1 Q. Paragraph 2 of the Application states that Hydro has been studying long-term supply options, in
2 particular the possibility of interconnection, for certain communities in southern Labrador since
3 the early 2000s. Please explain why Hydro is proposing interconnection as the long-term supply
4 option at this time, especially in light of increasing rate pressures and rate mitigation efforts.

1 **Material Capital Investment Required to Address Charlottetown Supply**

1 **Chart 1: CPV Analysis Including O&M, Fuel and Overhaul Costs**

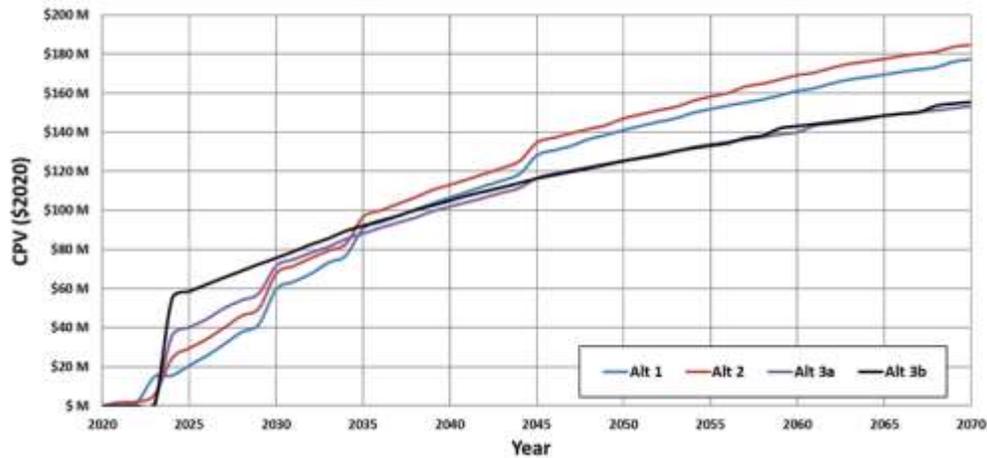
2 Chart 1 presents the results of Hydro’s cost benefit analysis over the 50-year planning horizon.⁶

16 Hydro’s analysis indicates that Alternative 3a is the least-cost alternative and its benefits are
17 realized at approximately 15 years into the study period – relatively early in the study period
18 when considering the overall study period of 50 years.

9 **Chart 2: Incremental Revenue Requirements for Interconnection (Alt 3a)**
 10 **vs. Mobile Generation (Alt 1)**

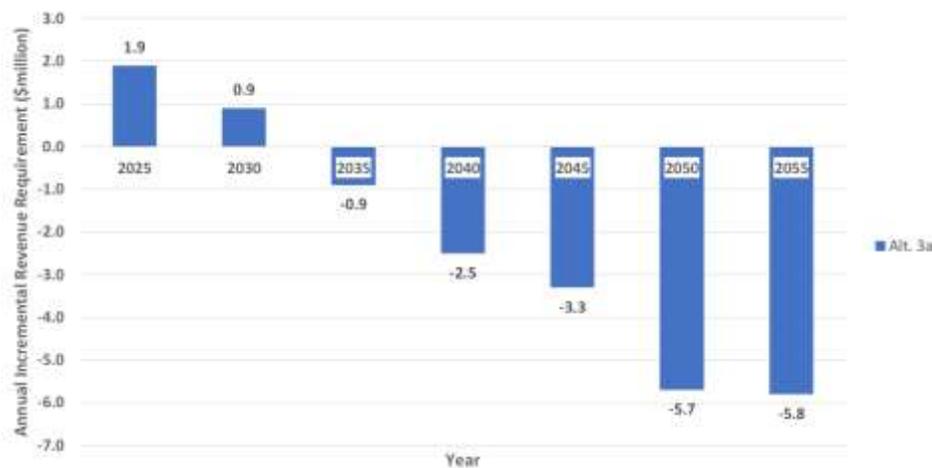
3 Chart 2 highlights the incremental revenue requirement impacts for Alternative 3a compared to
 4 that of Alternative 1. Compared to Alternative 1, the interconnection of the southern Labrador
 5 communities is expected to generate an incremental revenue requirement increase until 2035
 6 due to higher upfront capital costs. In 2035 and beyond, Hydro forecasts a reduction in net
 7 incremental revenue requirement due to the decreased operating, maintenance, fuel and
 8 overhaul costs.
